ADDENDUM #2

NOTICE TO ALL BIDDERS FOR
CITY OF WINCHESTER

ITB #202005 – Valley Avenue Improvements

PROJECT	SHEET NO.
U000-138-R04	20(5)

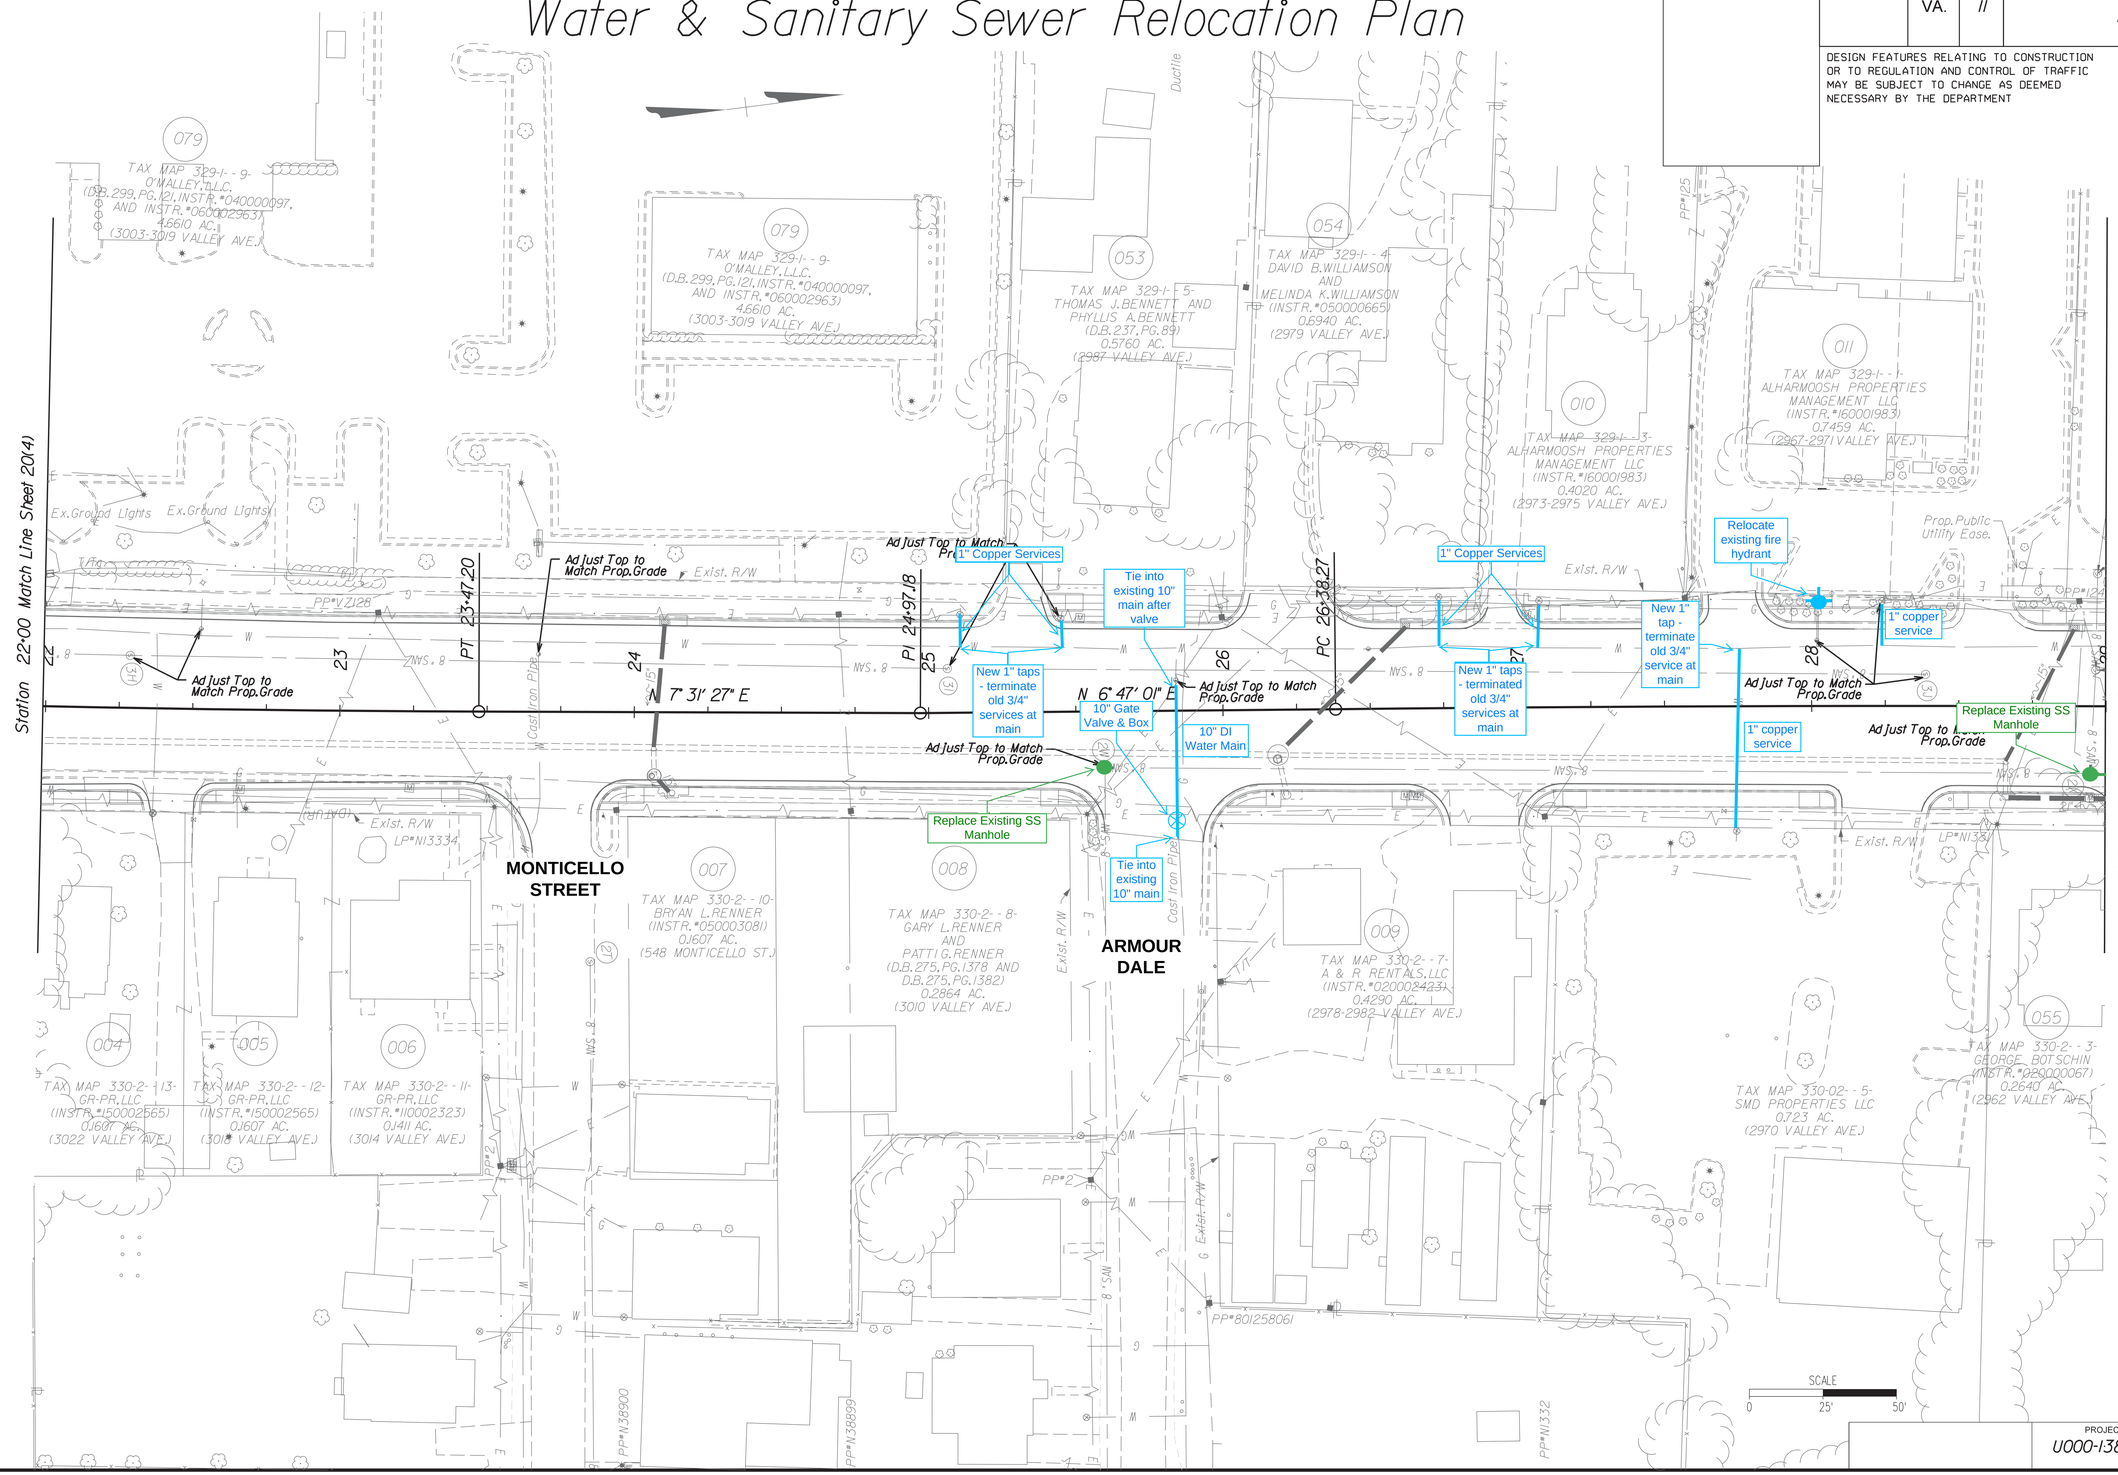
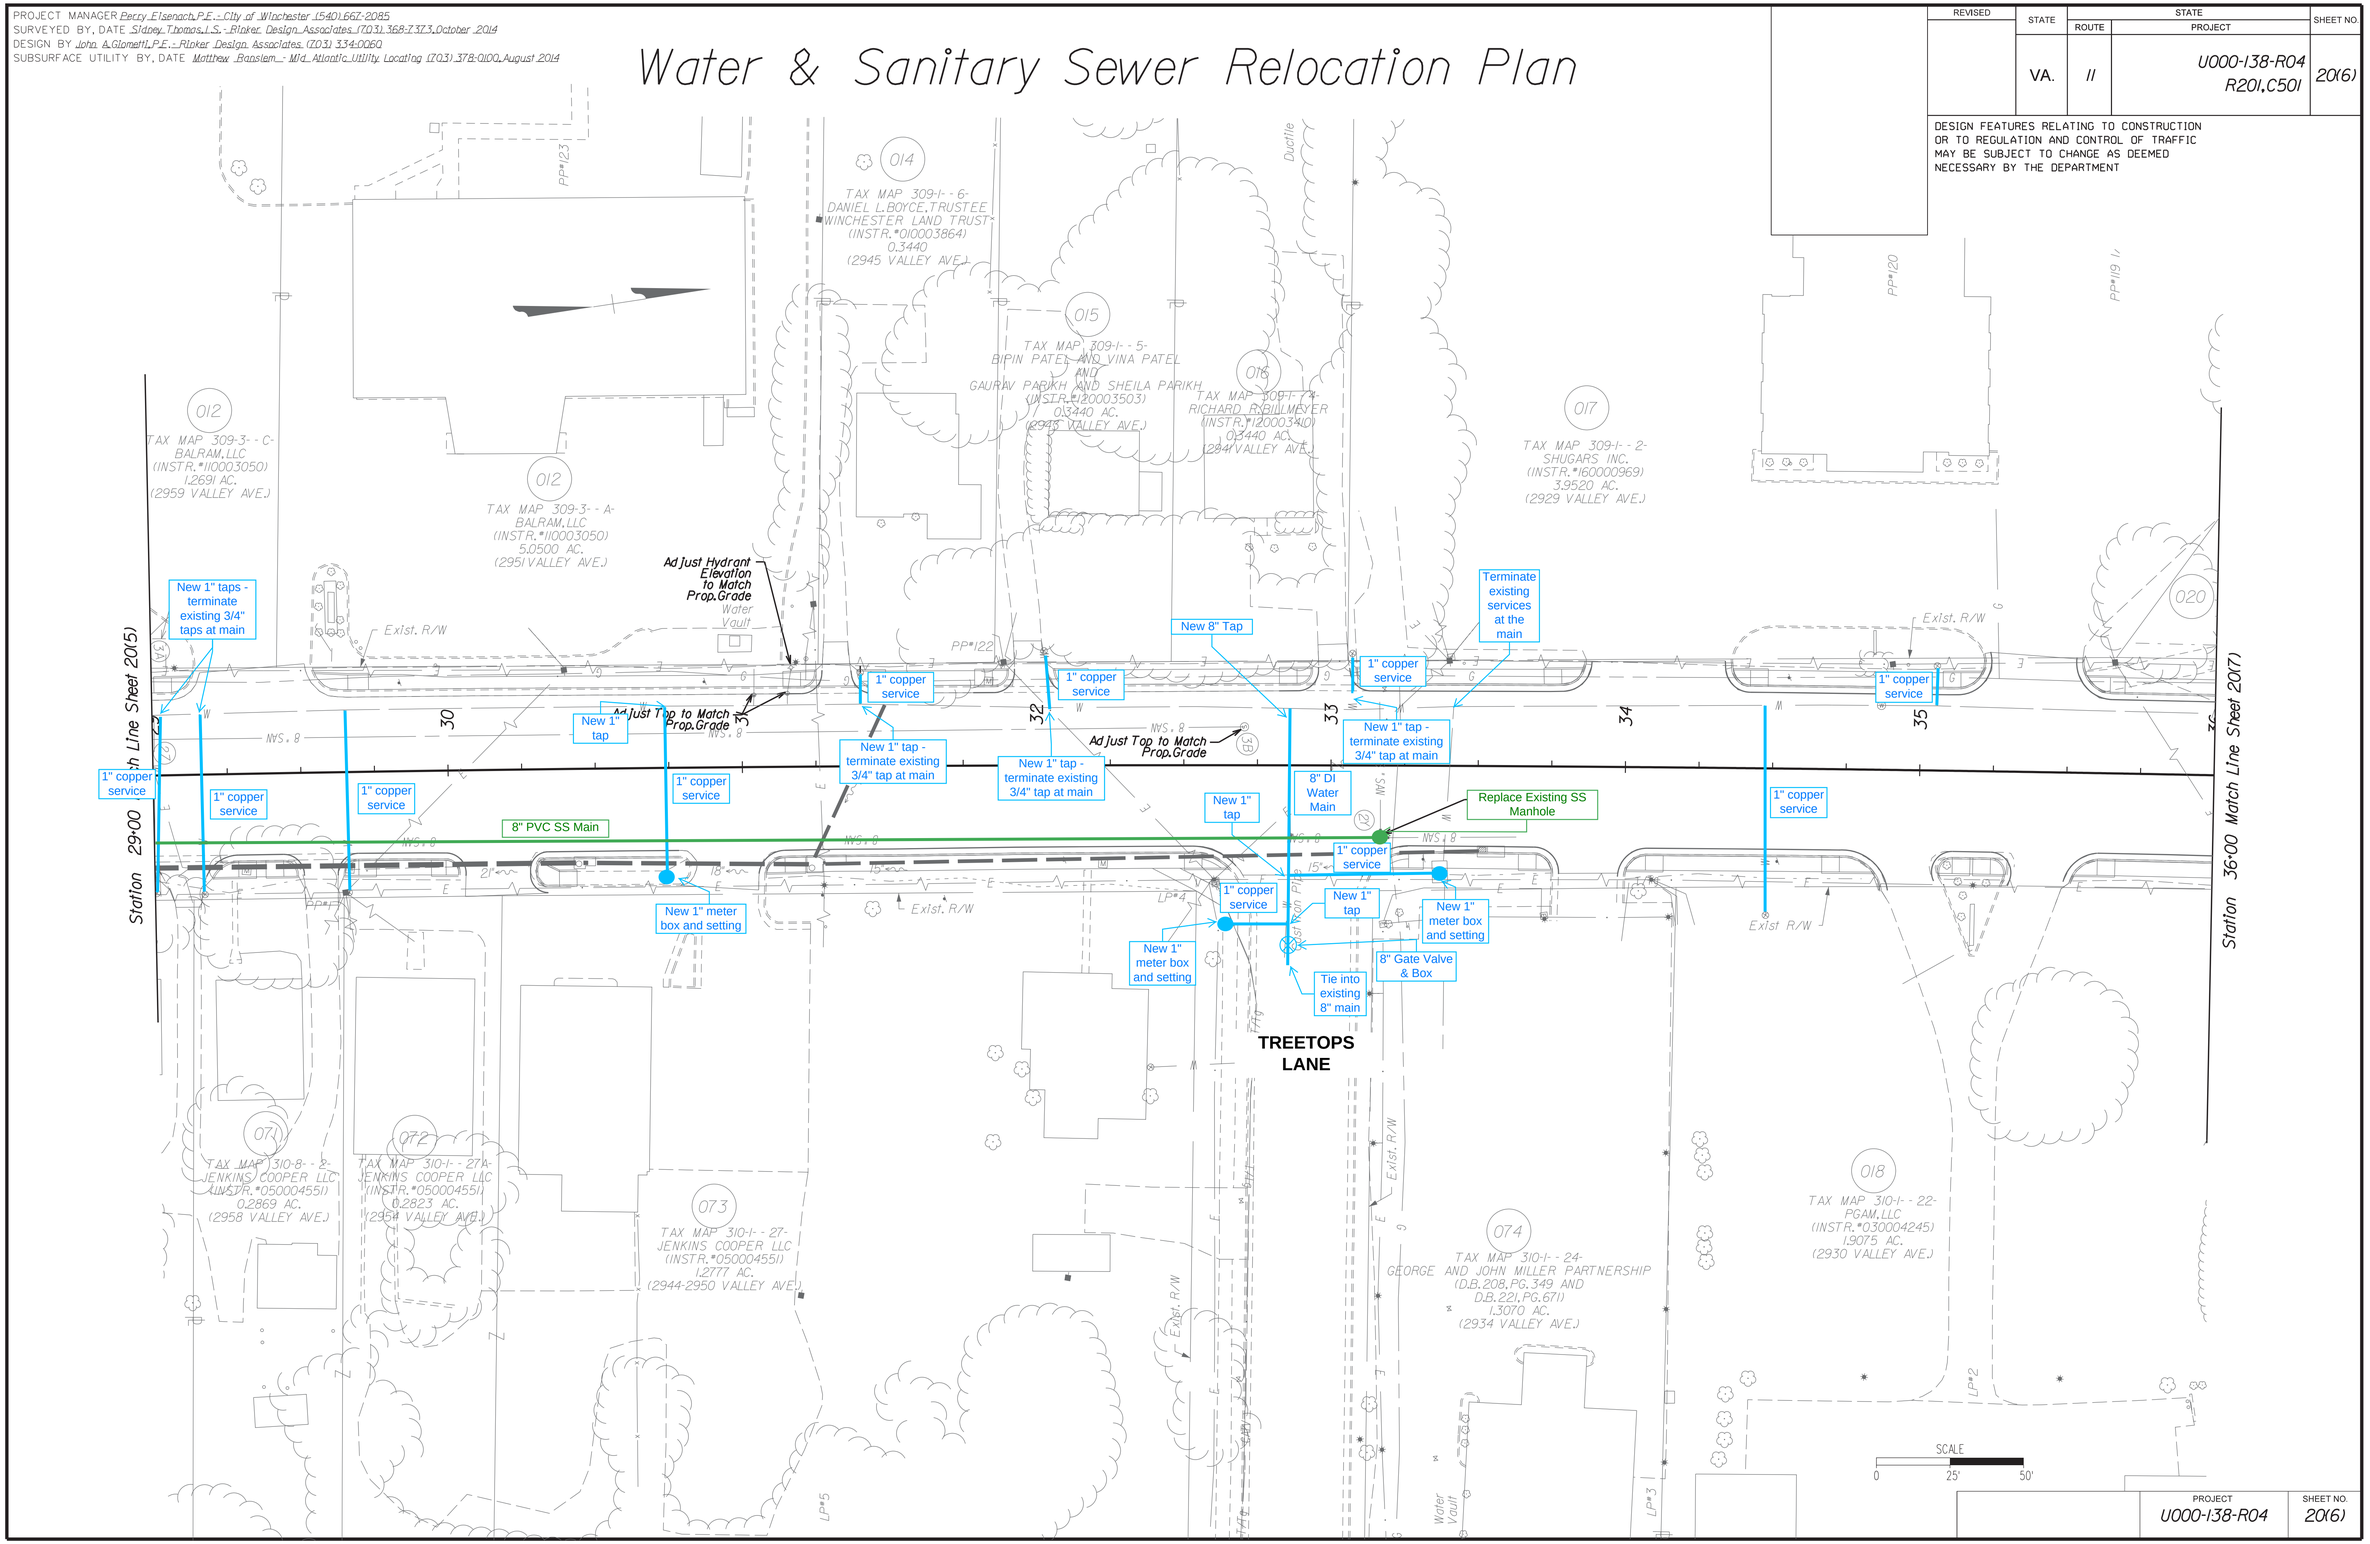
6. There have been numerous additions made to the water and sewer replacements for this project that are included in the revised Bid Form. The original plans have been modified with color showing this information and are attached.
